INSTRUCTION SHEET FOR 307339 MAGNETIC STARTER REPLACEMENT KIT

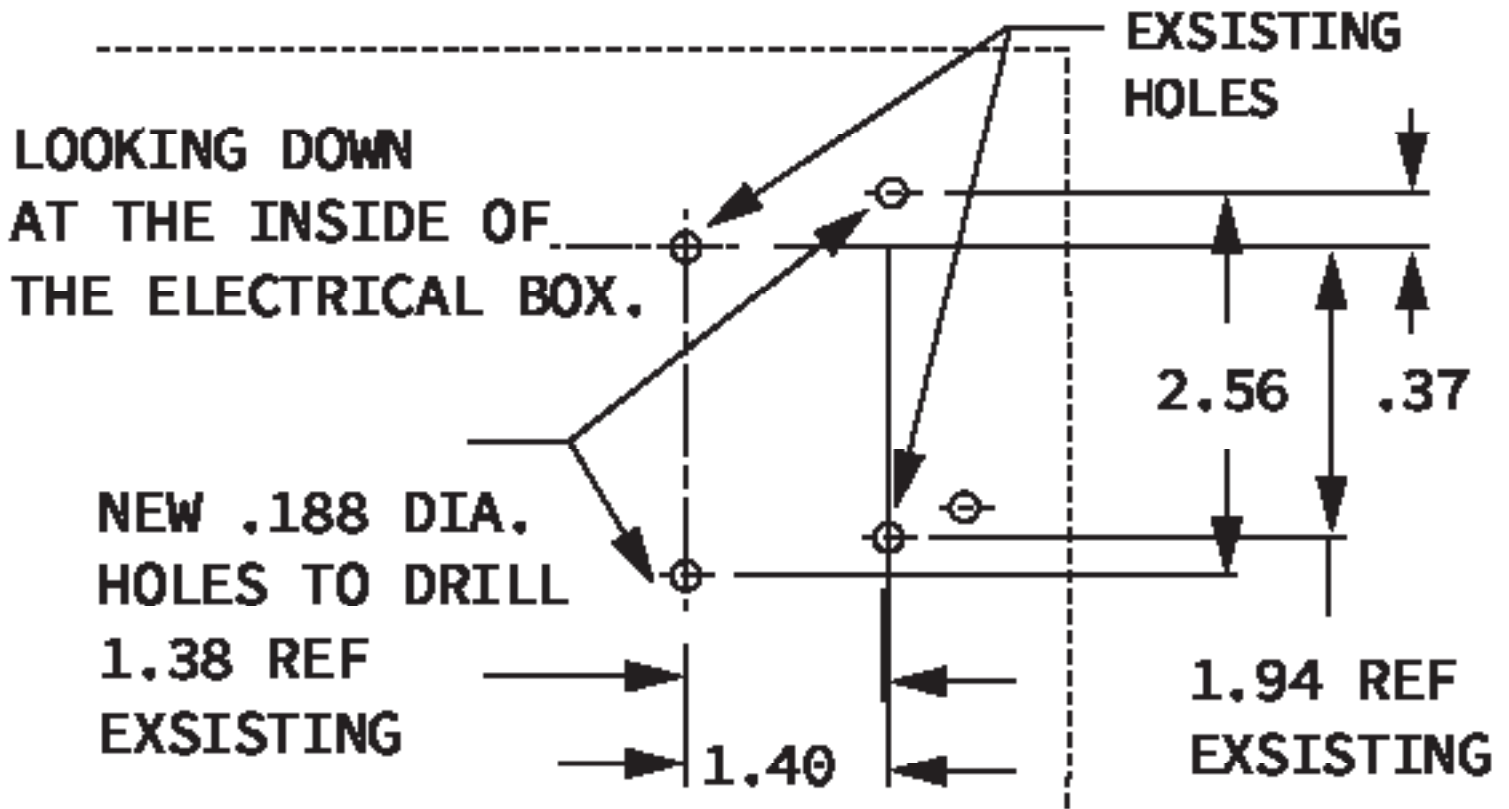
1. THIS KIT REPLACES MAGNETIC STARTER 3707087 WHICH WAS DISCONTINUED BY THE SUPPLIER.
2. THIS KIT CONSISTS OF A 3707556 MAGNETIC STARTER, A 3707557 OVERLOAD AND THIS INSTRUCTION SHEET.
3. REMOVE ALL WIRES FROM THE OLD MAGNETIC STARTER AND REMOVE AND DISCARD THE OLD STARTER.
4. MEASURE, MARK AND DRILL TWO .188 DIA. HOLES IN THE BOX IN THE BELOW DRAWING.
5. INSTALL THE NEW MAGNETIC STARTER AND OVERLOAD IN THE BOX AND THEN RECONNECT ALL THE WIRES. THE LOCATION OF THE TERMINALS MAY BE DIFFERENT ON THE NEW STARTER AND OVERLOAD, BUT THE WIRES MUST GO IN THE TERMINALS PER THE WIRE LABEL.
